TRANS/WP.29/GRSP/2003/12
5 September 2003

PROPOSAL FOR DRAFT AMENDMENTS TO REGULATION No. 14
(Safety-belt anchorages)

Transmitted by the Expert from Germany

Figure 1a

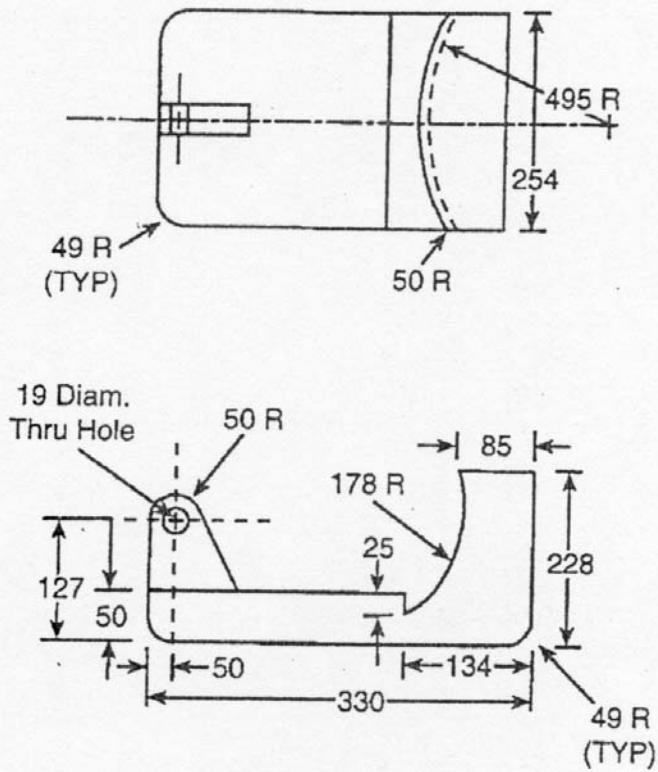
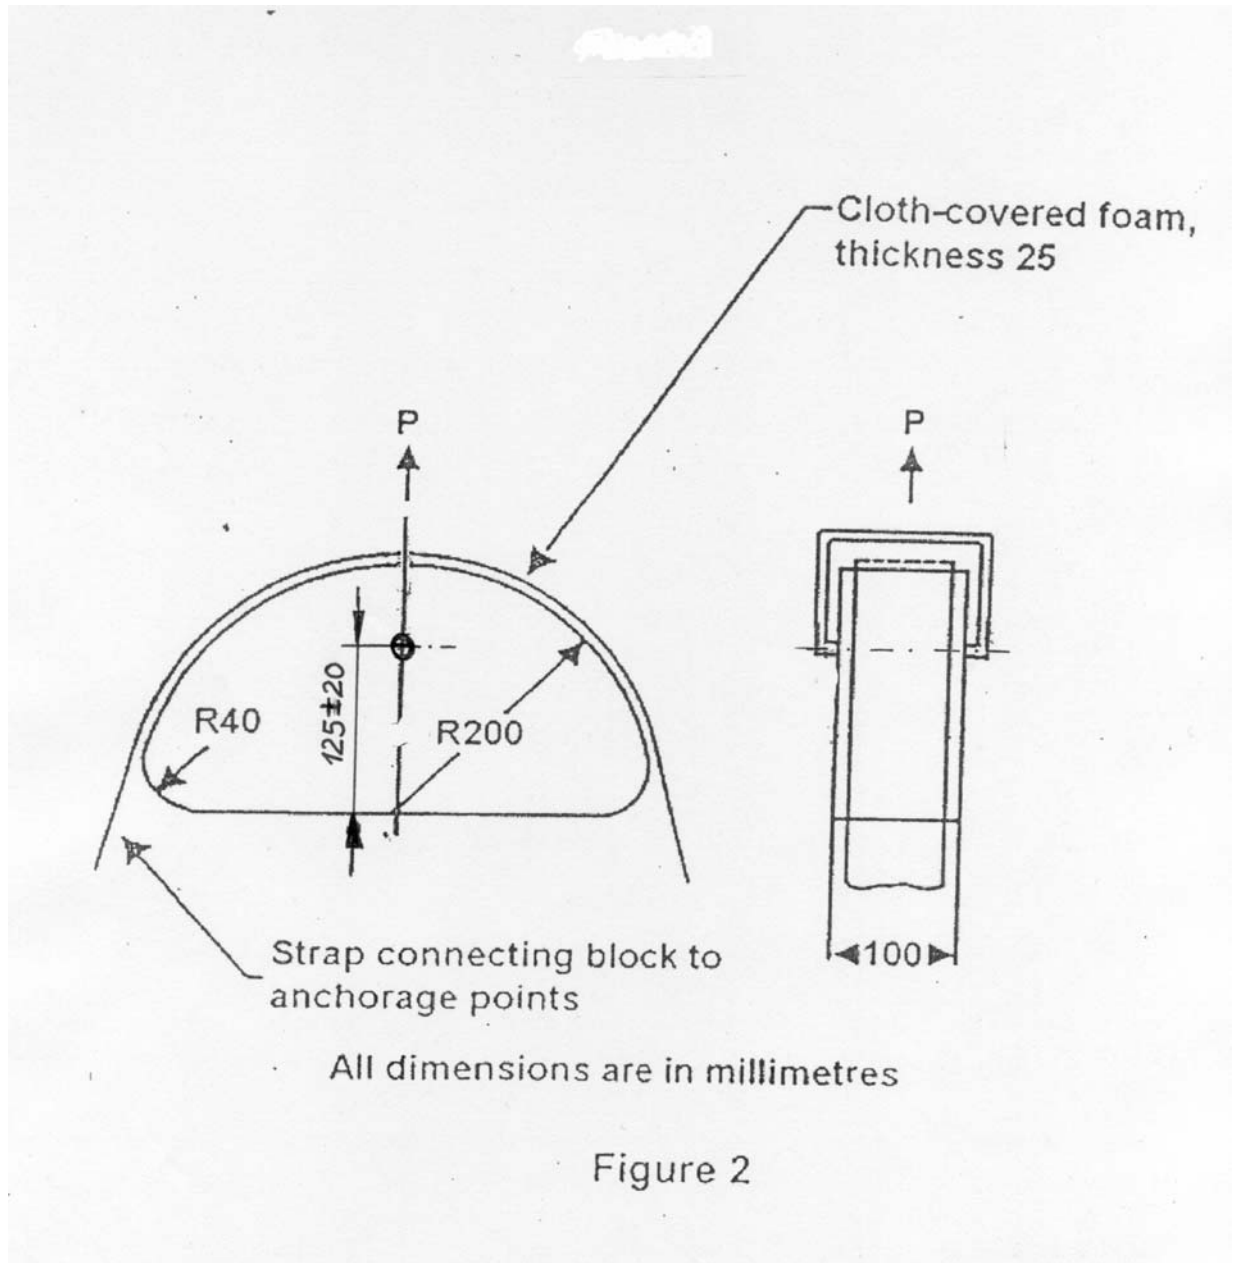
Instead of the lap belt traction device a similar device with a width of 254 mm shown in annex 5, figure 1a may also be used.

Insert a new figure 1a, to read:

In case of the use of the lap belt traction device, it should be allowed to use also a smaller traction device as shown in FMVSS with a width of 10" or 254 mm. This modification is helpful in case of the test of anchorages of a seat bench, where three or four traction devices cannot be installed in the tested vehicle. In addition, it is recalled that a width of effective anchorages of 240 mm has been introduced for special seating positions and this can be tested using the smaller traction device too.
